# 1101 WESTERN AVE

Early Design Guidance #2  
SDCI # 3033606-EG  
July 9, 2019

SUMMARY OF BOARD COMMENTS: EDG #1

VOLUMETRIC SECTIONS - OPTION 2

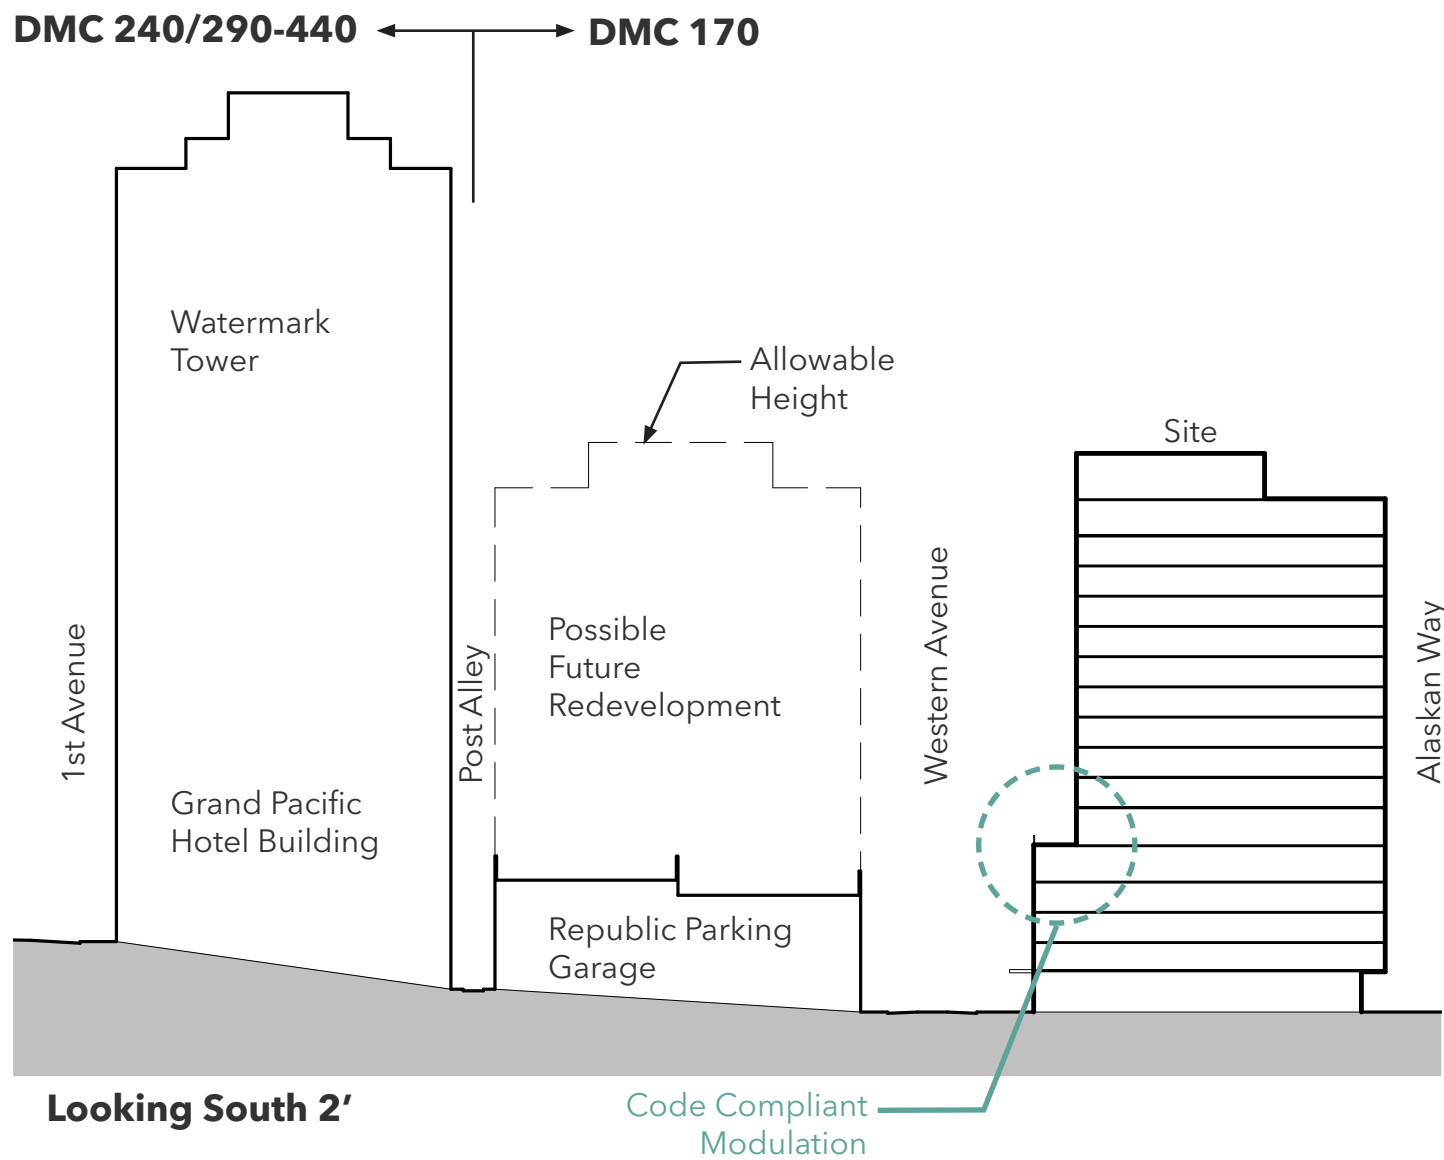
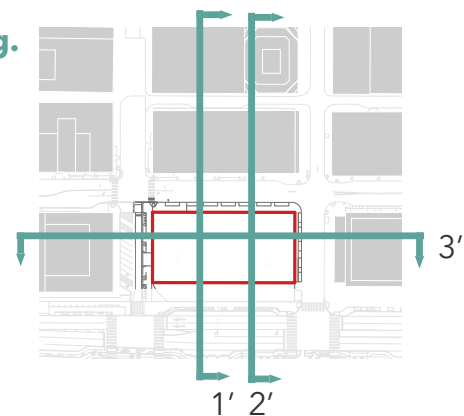
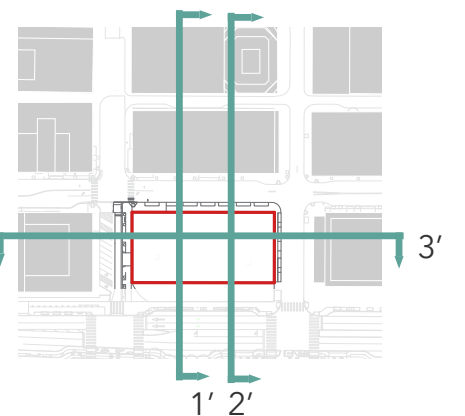
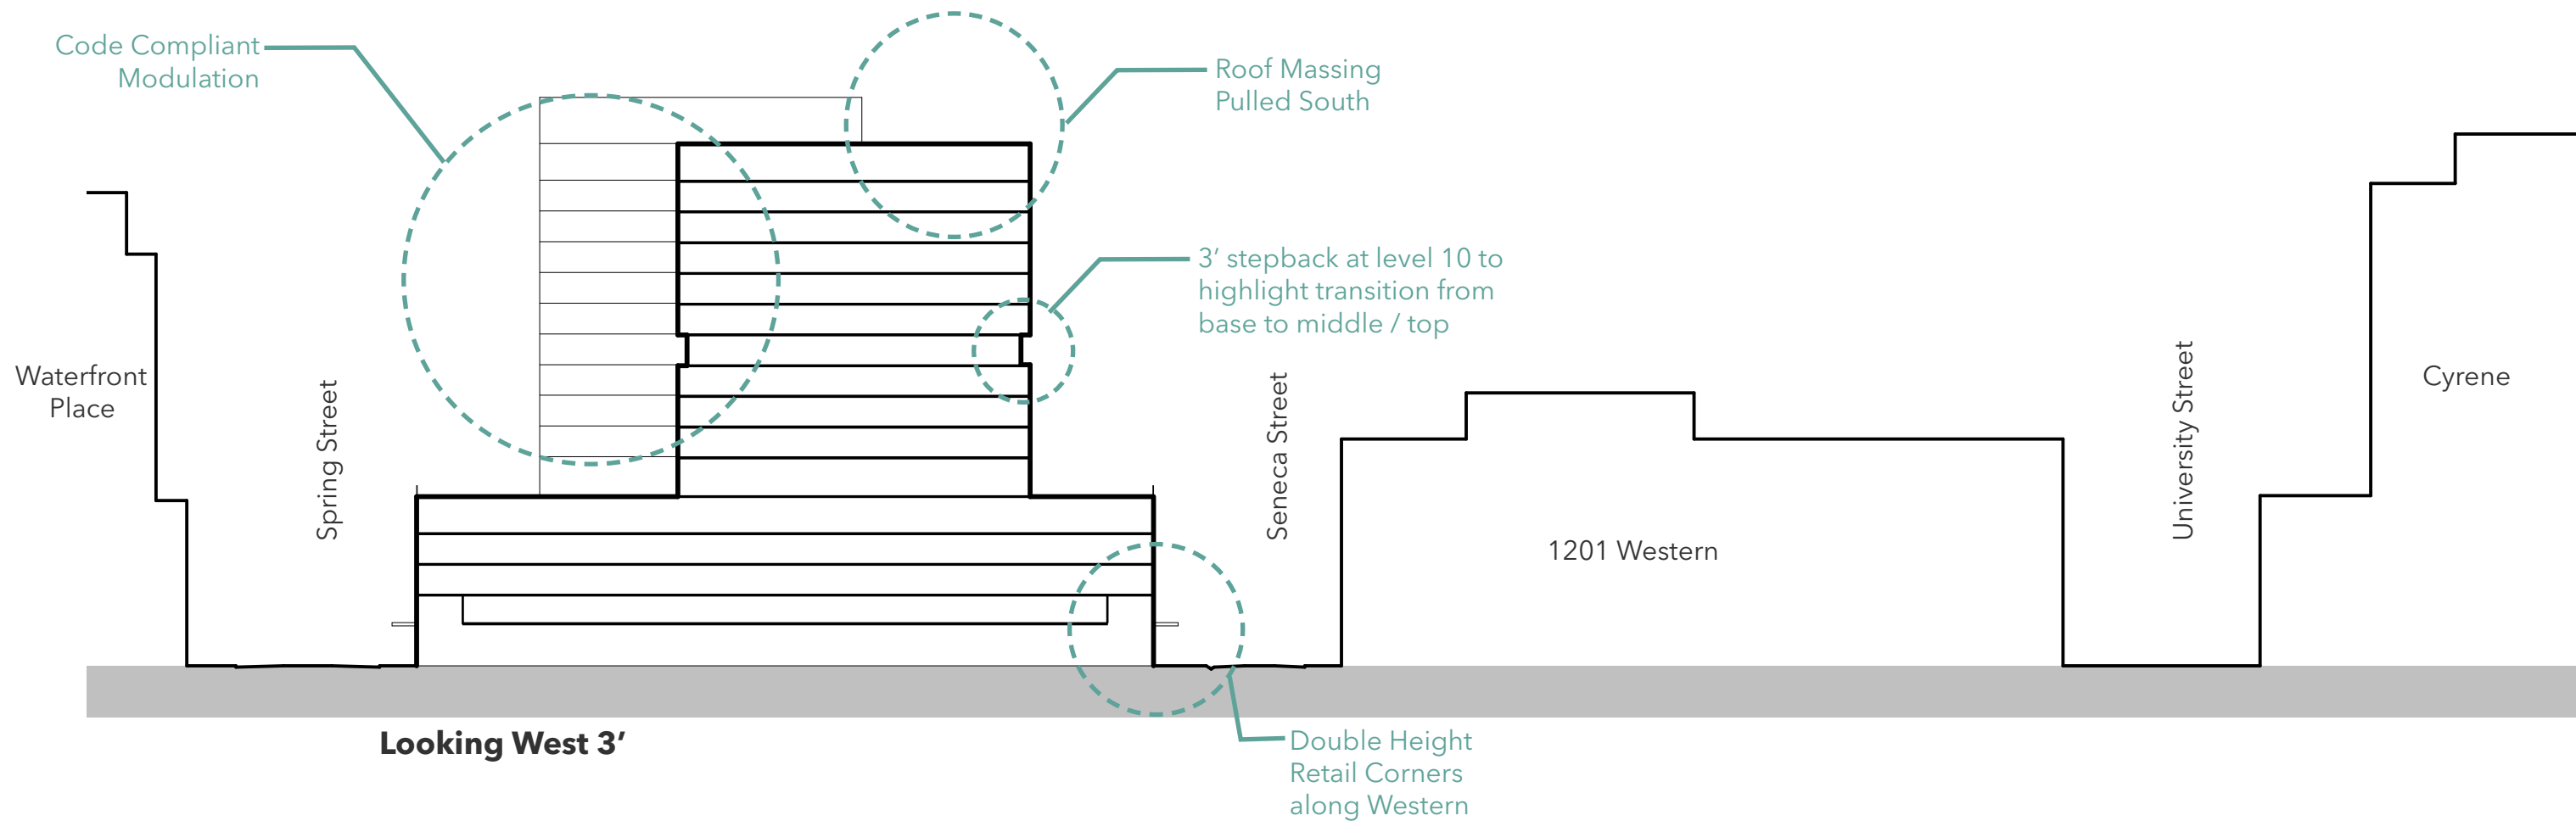
**The Board requested that the design team provide sections through the massing options to show the volumetric massing of each.**

Reveals and deck recesses emphasize and create appropriate transitions between building masses and material languages.

GROUND LEVEL UNITS

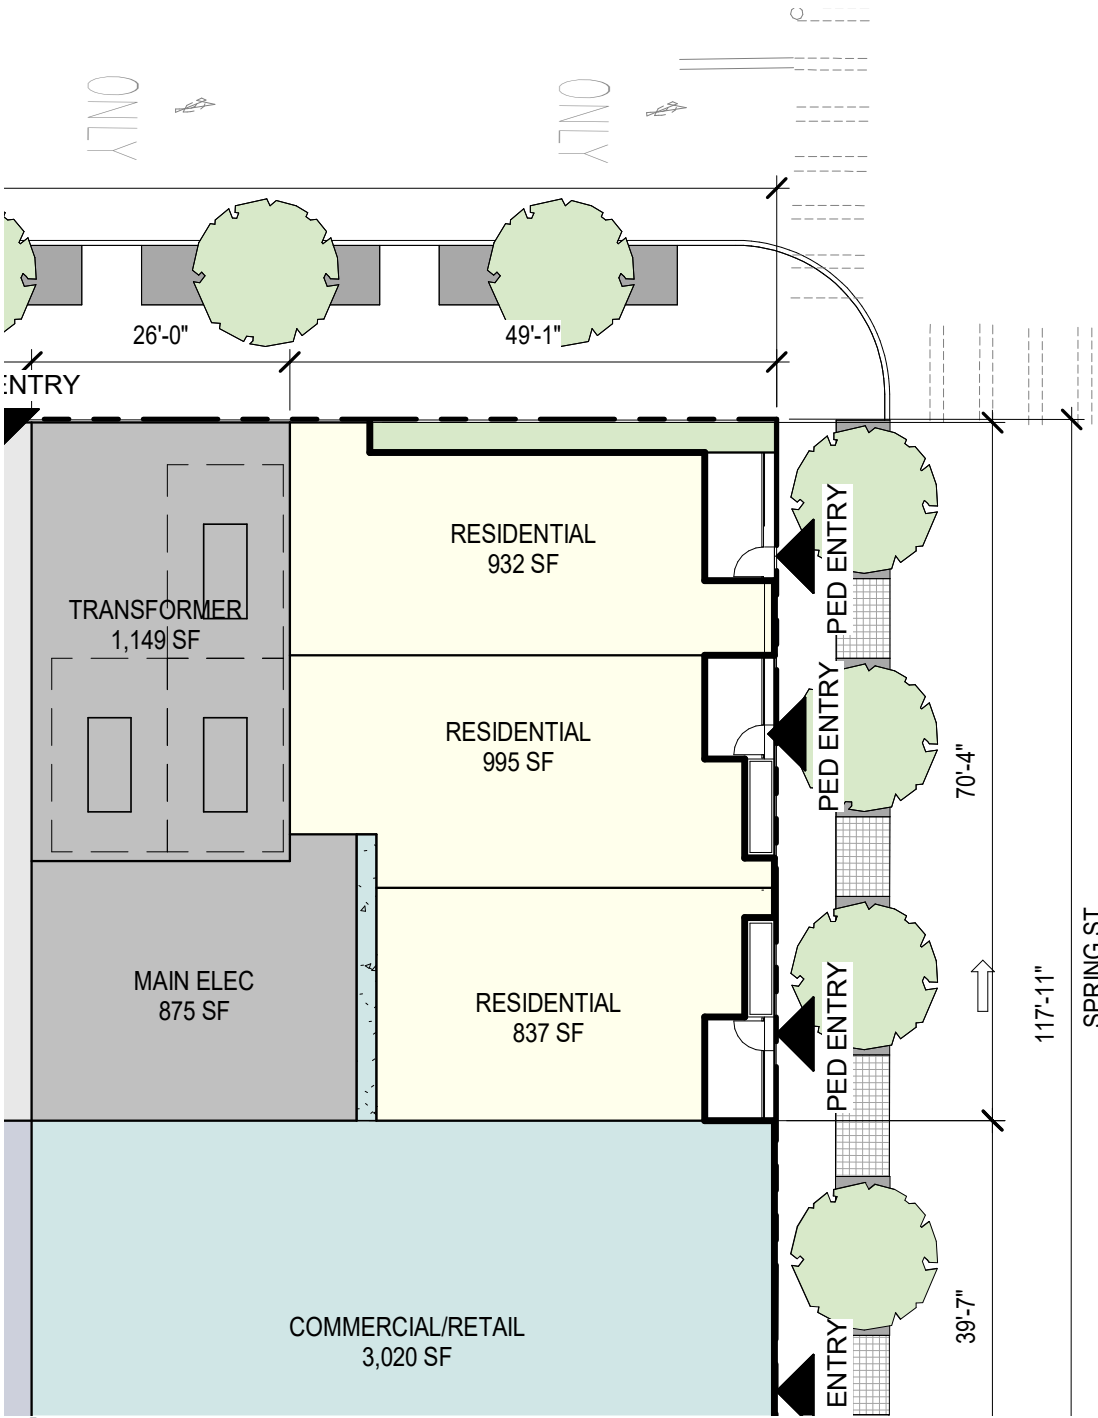
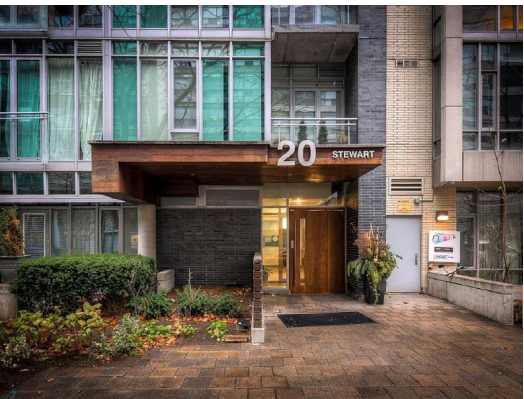
At EDG Meeting #1 the board questioned if there was precedent for ground level residential units on Western. The Design team found one instance on Western Avenue but also relevant precedent studies in downtown and nearby South Lake Union. These case studies were instructive in shaping the vision for the proposed character of ground level units along Spring Street, Western Ave. and Seneca Street. Street level perspective demonstrate how screened service functions can make appropriate neighbors. Critical elements included in ground level unit design are vertical and horizontal separation from the street, unit porches with individual gates, a balance of glazed and solid exterior, lighting, street facing identity, and exterior planters. Proposed residential units will be over framed so that they can be reconfigured to function as retail spaces and easily respond to the evolving waterfront.

Raised stoops provide separation and privacy from sidewalk

Fence protecting residential from street

# DESIGN RESPONSE - 9 BLOCK CONTEXT

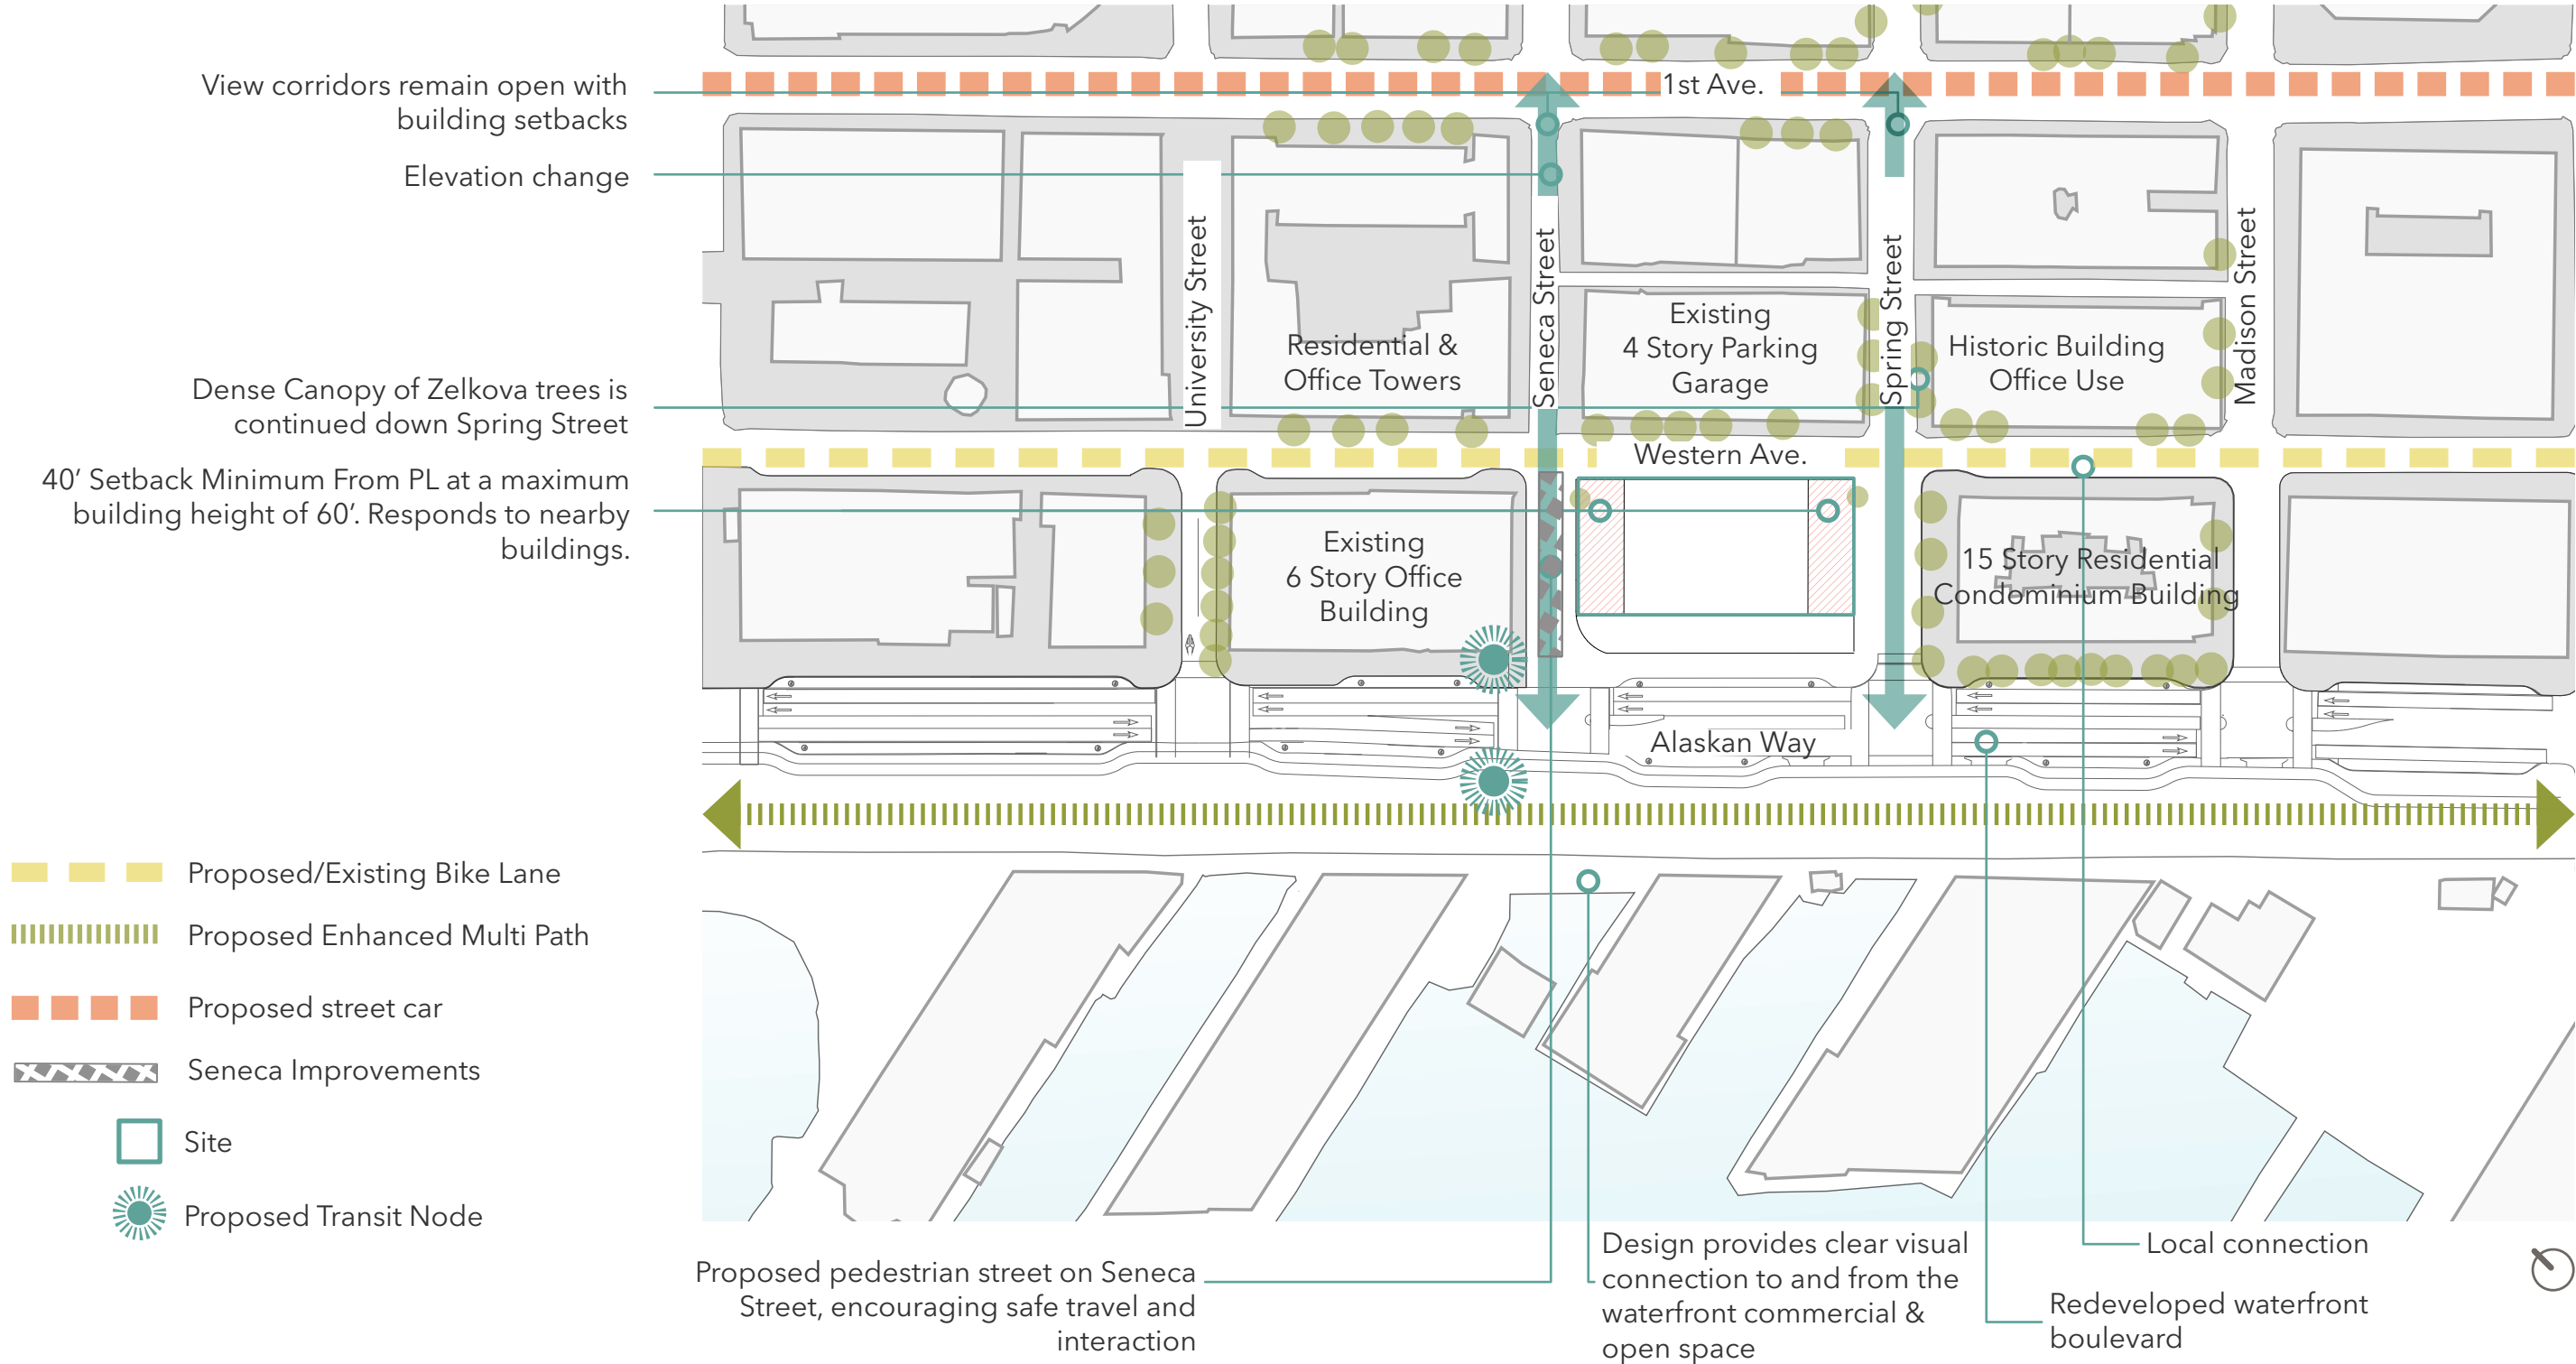
The Board requested that the design team provide a diagram of the 9-block area around the site that shows/labels pedestrian entries, street uses, and vehicle access points. This study of Western reveals multiple pedestrian, vehicular and service entrances as well as a variety of ground level uses. This section of Western is very much in transition. Both design options minimize impact of vehicular traffic on Western but explore programmatic options that are appropriate given the emergent pedestrian qualities of the site.
